MINERALS PROGRAM INSPECTION REPORT

MINE NAME: Cross Gold Mine	MINE/PROSPECTING ID#: M-1977-410	MINERAL: Gold, copper, silver, zinc and lead	COUNTY: Boulder
INSPECTION TYPE: Preoperation Inspection	INSPECTOR(S): Amy Eschberger, Peter Hays	INSP. DATE: June 24, 2021	INSP. TIME: 10:00
OPERATOR: Grand Island Resources LLC	OPERATOR REPRESENTATIVE(S): Richard Mittasch, Daniel Pollock	TYPE OF OPERATION: 110(2) - Hard Rock Limited Impact

This was a pre-operation inspection of the Cross Gold Mine (Permit No. M-1977-410) conducted by Amy Eschberger and Peter Hays of the Division of Reclamation, Mining and Safety (Division) in response to an Amendment application (AM-2) filed with our office on February 8, 2021. The inspection was also partly conducted to observe the stabilization work completed on the slope above the Idaho Tunnel portal in relation to the Division's review of Technical Revision No. 9 (TR-9). The operator was represented during the inspection by Richard Mittasch and Daniel Pollock. The site is located approximately 4 miles northwest of Nederland, CO in Boulder County, at an elevation of approximately 9,760 feet. Access to the site is off of Caribou Road. A separate entrance

Project		DRMS Amendment 2	
Title		EXHIBIT E	
		Proposed Permit Boundary Modifications	
	Project No. CO-0801		File No.
	GIS:	JST 05/17/21	Scale As Shown
	Check:	JST 05/17/21	Rev 0
	Review:	DP 05/17/21	Map 2

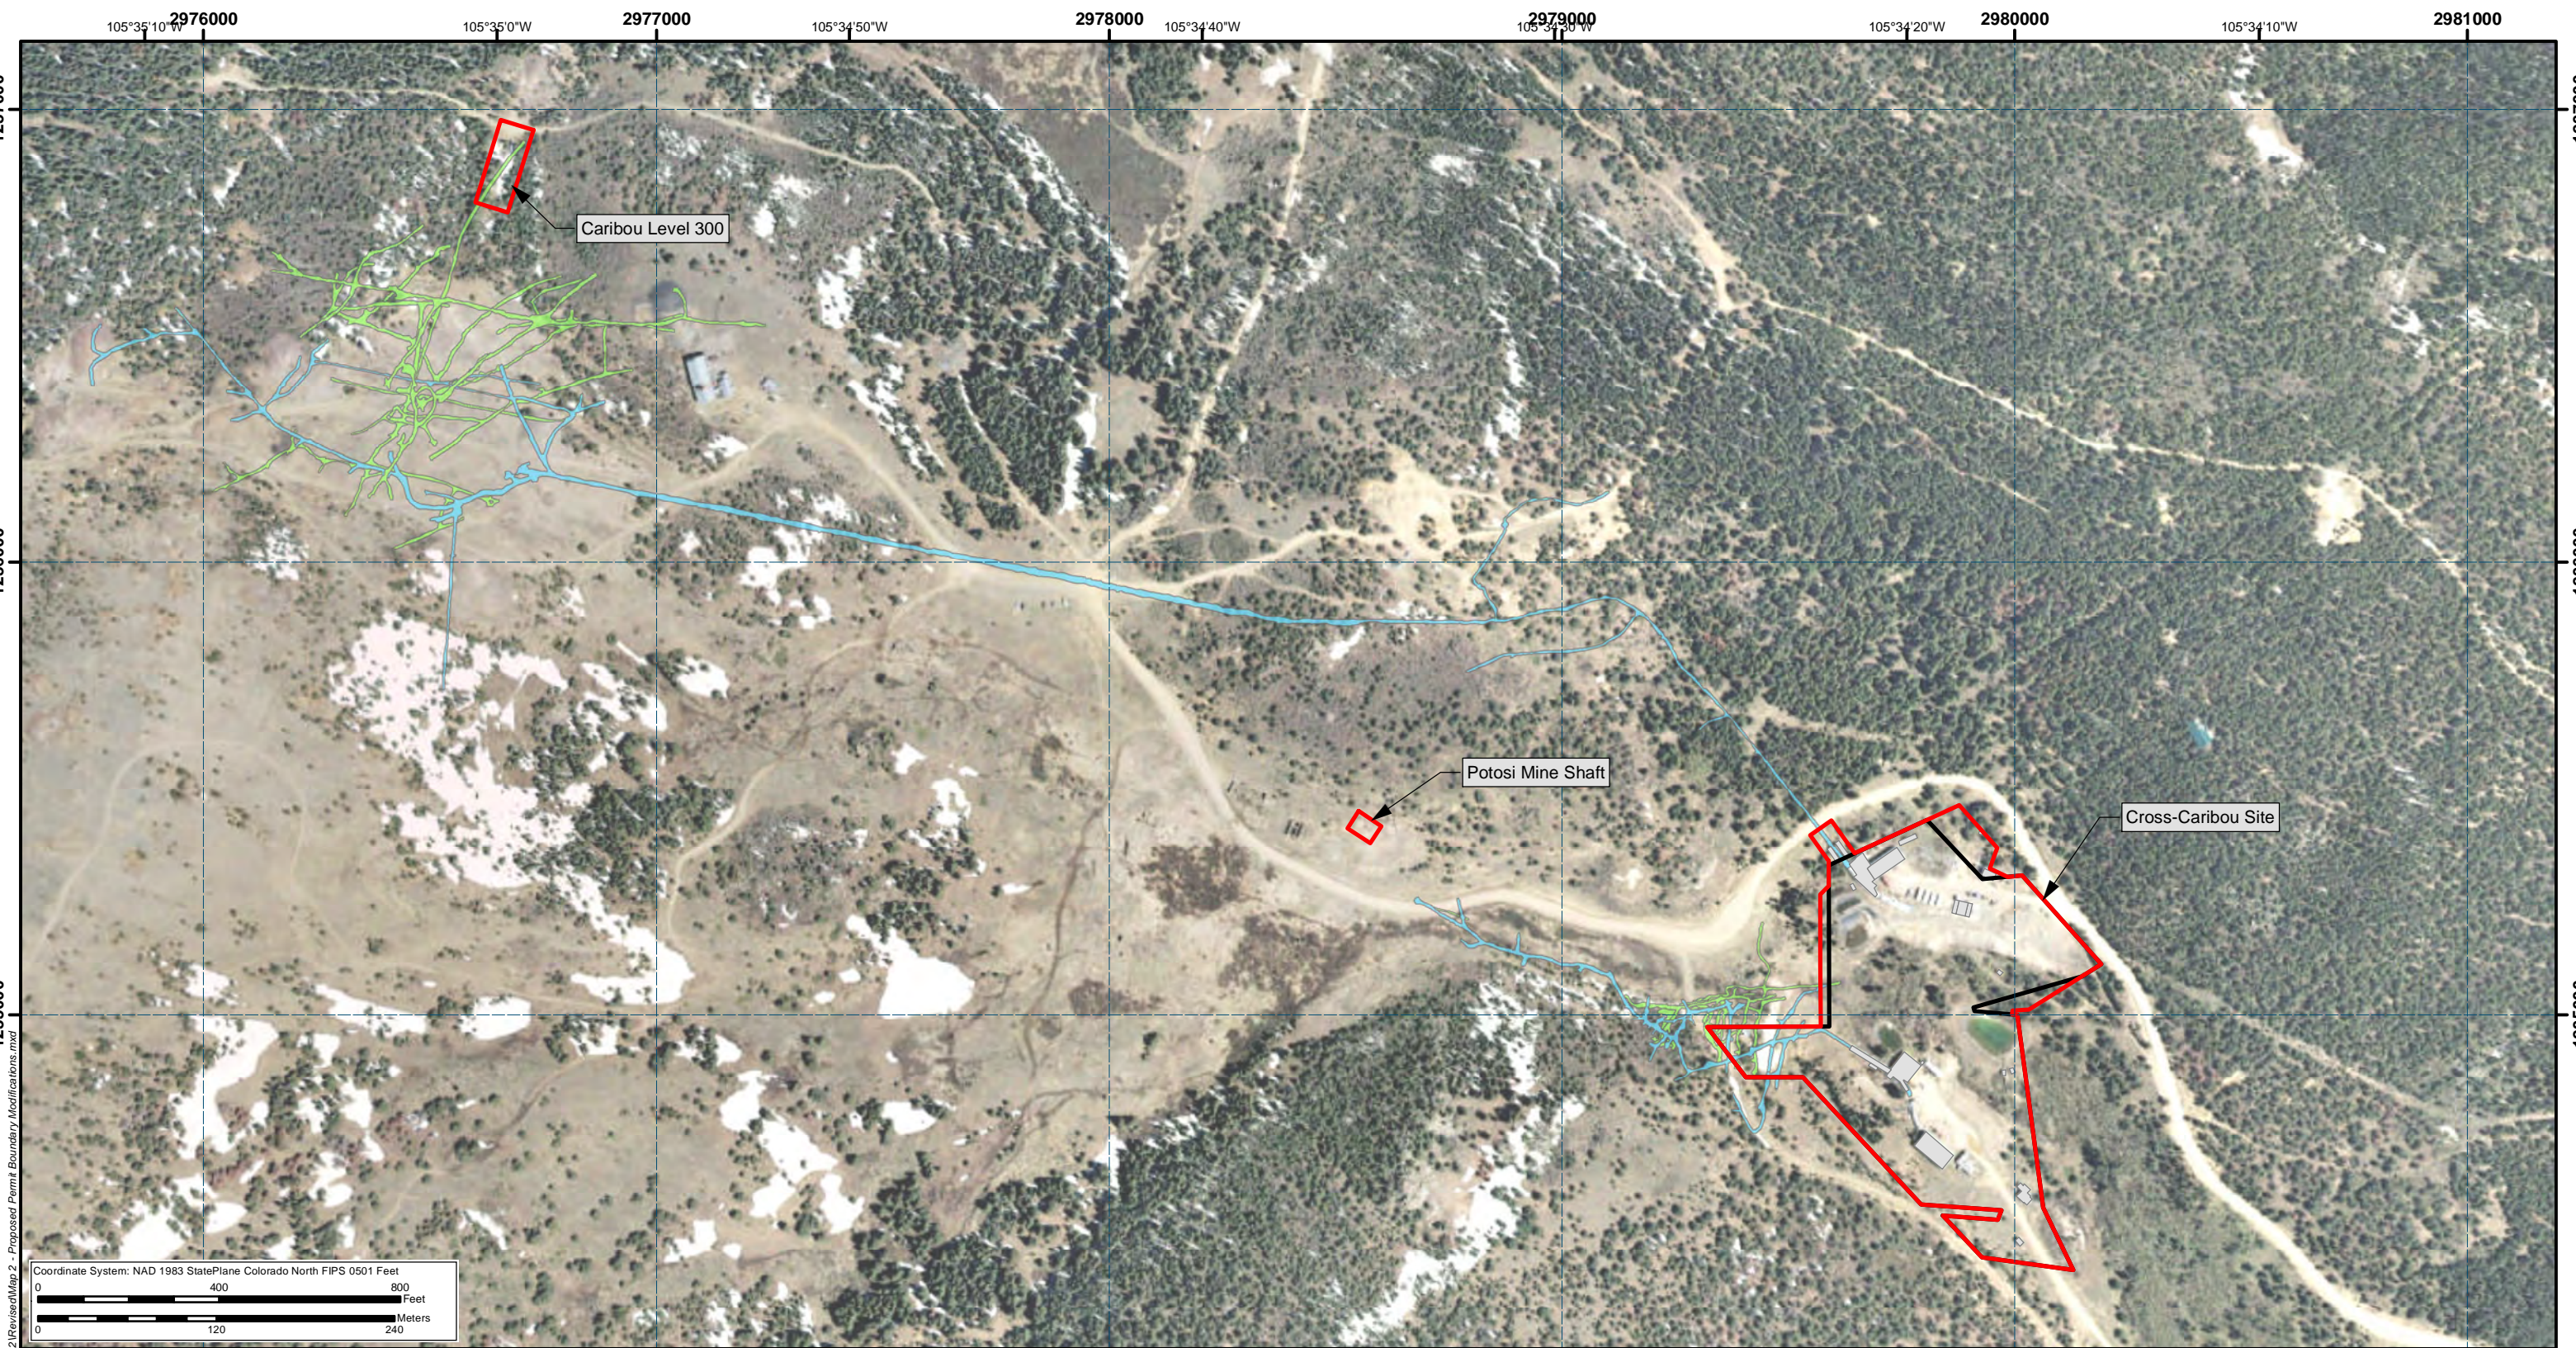
AM-2 proposes a 1.04 acre increase in the permit area (see enclosed Exhibit E – Map 2), for a new permit area of 9.99 acres (the maximum permit area allowed under a 110 permit; an expansion to 10 acres or more would require a permit Conversion to a 112 permit). The proposed increase includes four small expansion areas at the

Project	DRMS Amendment 2			
Title	EXHIBIT E Proposed Permit Boundary Modifications Cross-Caribou Site			
	Project No. CO-0801		File No.	
	GIS:	JST	05/17/21	Scale As Shown
	Check:	JST	05/17/21	Rev 0
	Review:	DP	05/17/21	Map 3

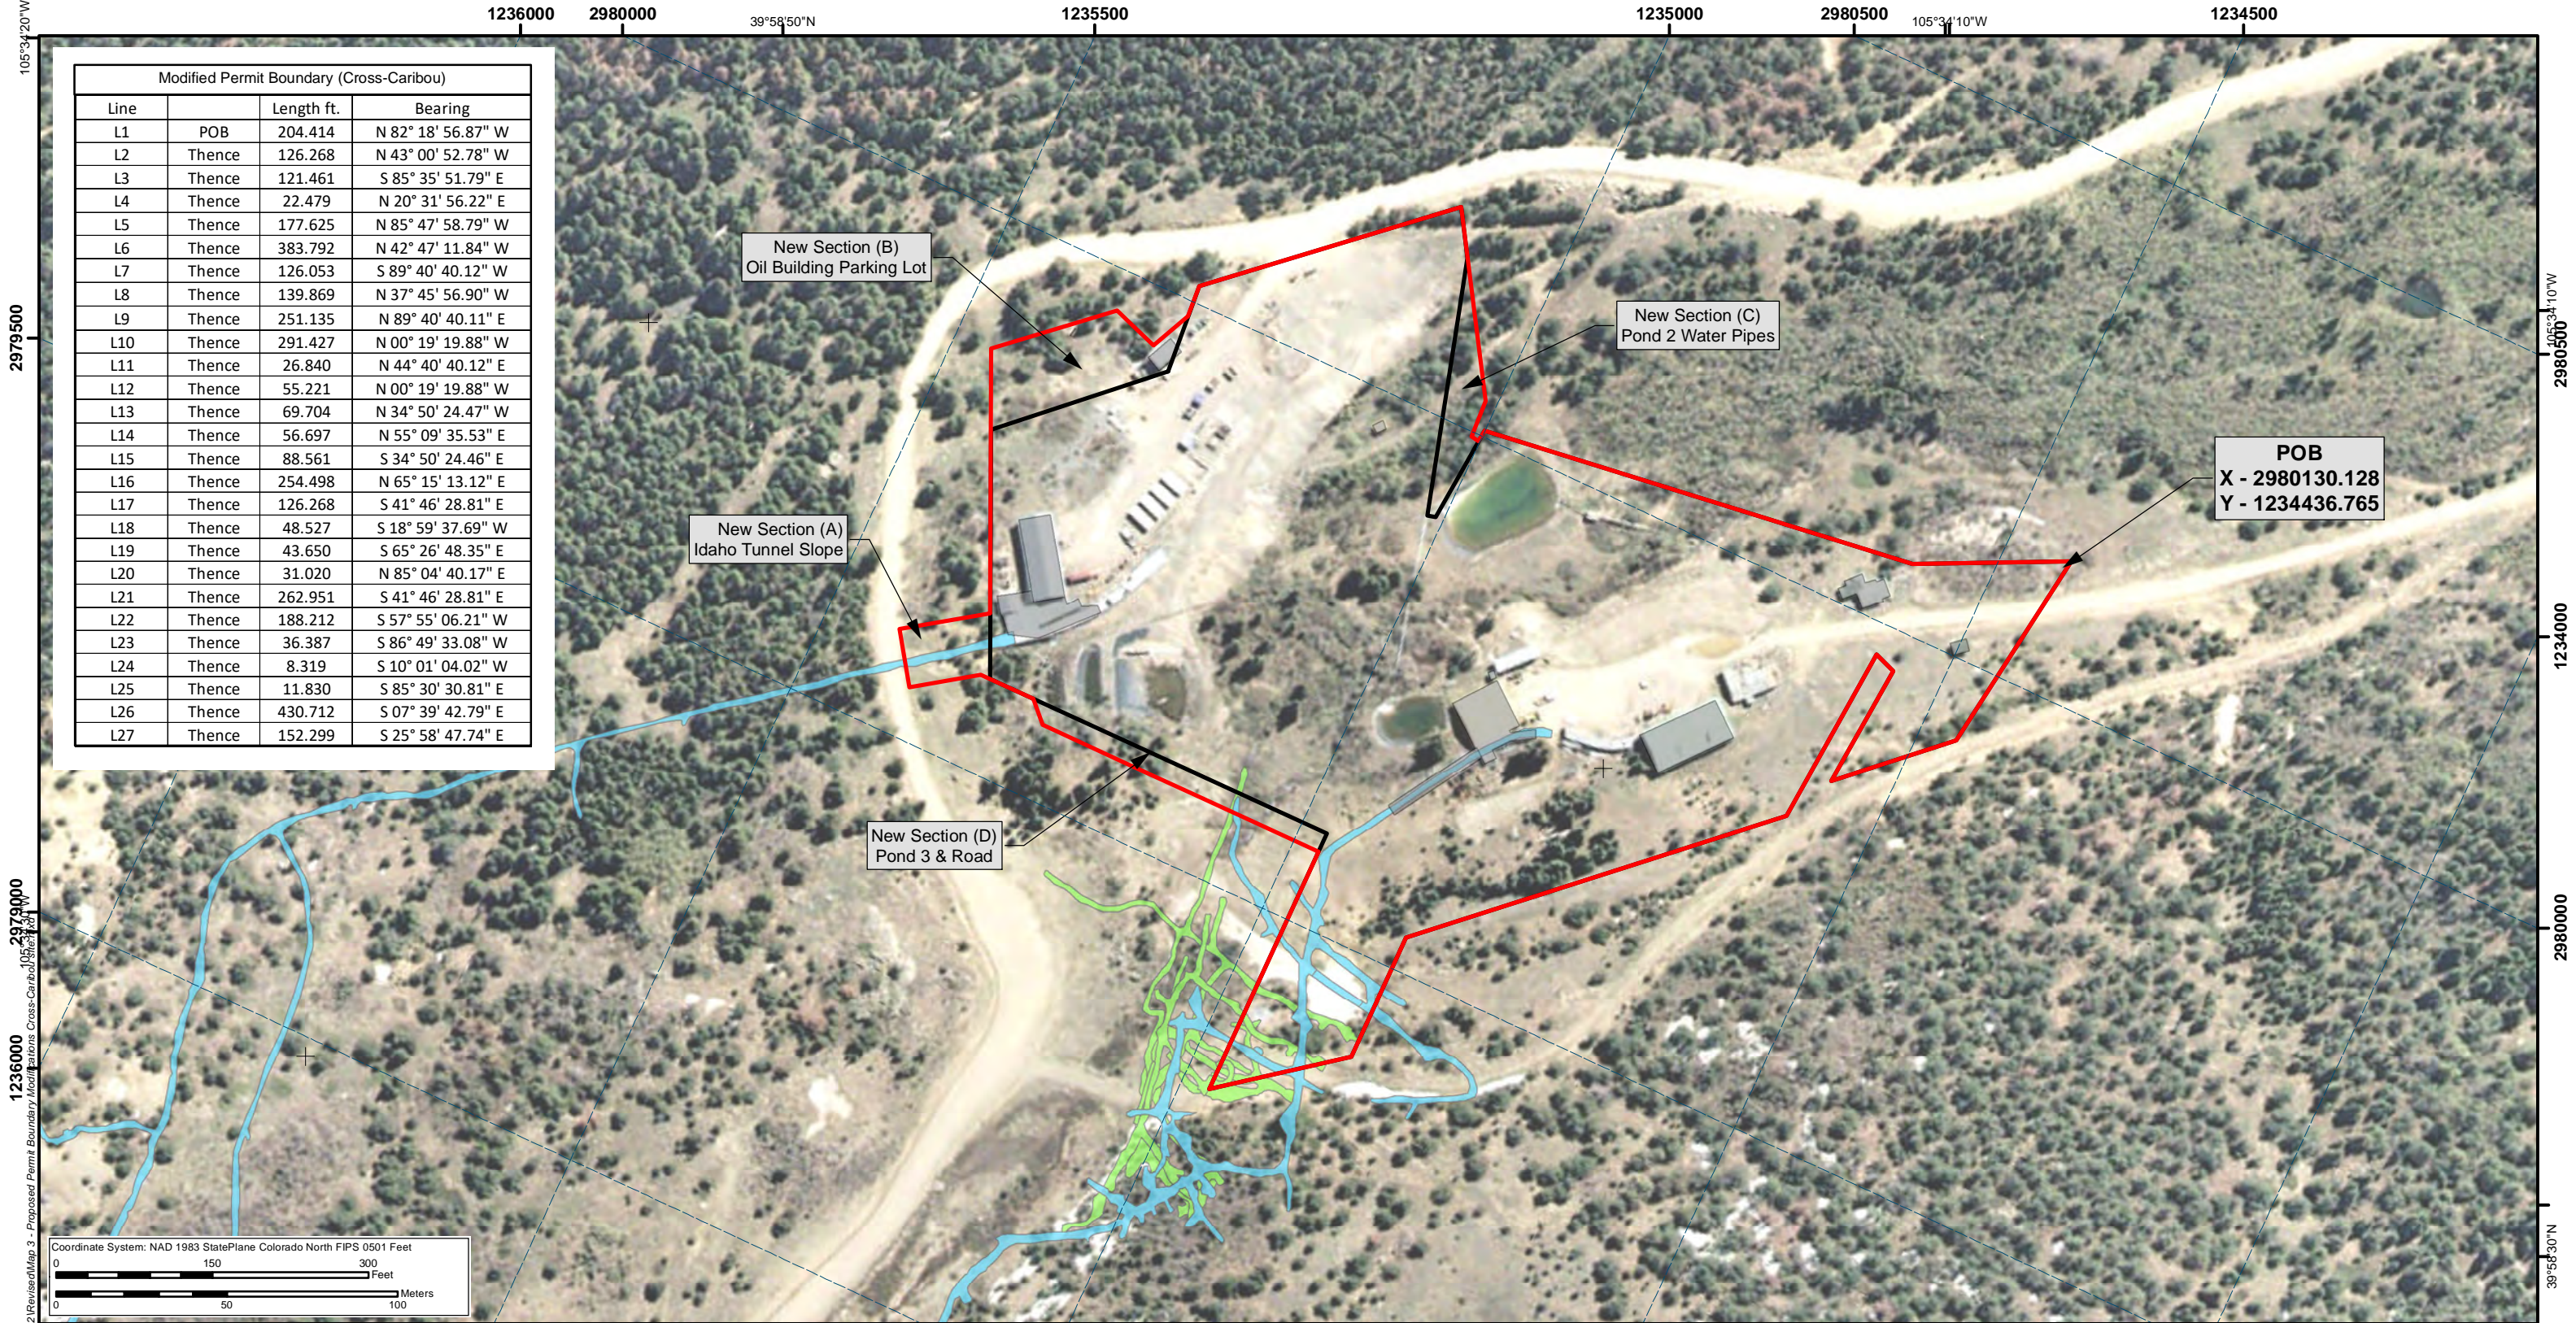
Cross-Caribou site, totaling 0.65 acres (see enclosed Exhibit E – Map 3), and two new mine openings located above the site, totaling 0.39 acre (see enclosed Exhibit E – Map 4). The proposed expansion areas at the Cross-Caribou site cover the off-site affected lands at the Idaho Tunnel portal area, the oil shed and equipment storage area adjacent to the shed, the area west of Ponds 3A-3C, and the area north of Pond 2 (including a portion of the water pipelines). AM-2 also proposes constructing a new internal road (approximately 30 feet wide x 885 feet in length) at the Cross-Caribou site to connect the two mines, which would provide safer access from one mine to the other than the publicly-used Caribou Road which is currently used. The proposed expansion area west of Ponds 3A-3C will allow additional space to construct the new road. The two new mine openings proposed in the application include the existing Potosi Shaft, located approximately 0.35 mile northwest from the Cross-Caribou site, off of Caribou Road, and the existing Caribou Level 300 Portal, located approximately 0.9 mile northwest of the Cross-Caribou site, off of a U.S. Forest Service (USFS) Road.

The Division first inspected the Cross-Caribou site. The operator has delineated the four proposed expansion areas with white PVC pipes and t-posts. The proposed expansion area near Pond 2 consists mostly of undisturbed forestland and the northernmost corner of this pond (including a portion of the above-ground pipelines which discharge mine water into the pond). This area will only be used by the operation for running water pipelines to Pond 2. The proposed expansion area near Ponds 3A-3C includes a portion of Coon Track Creek and its associated wetlands, undisturbed forested areas, and the western edge of Pond 3A. Some disturbance in this area may occur in the construction of the new road between the Cross and Caribou Mines. An existing footpath exists between Pond 1 (at the Cross Mine) and Ponds 3A-3C (at the Caribou Mine). It appears the northern portion of the existing footpath may align with the location of the new road. However, the southern portion of the new road would bend to the east around the eastern edge of Pond 1 to connect to the Cross Mine area near the Cross office building.

The proposed expansion area near the existing oil shed at the Caribou Mine includes a portion of the oil shed and a cleared off area just west/northwest of the oil shed primarily used for equipment storage. AM-2 proposes the continued use of this area for equipment storage. However, one of the Exhibit E figures (Map 7) shows this

area to be used for additional waste rock storage. The Division has requested clarification on the planned use of this area by the operation. For reclamation, this area will be ripped, retopsoiled, and revegetated.
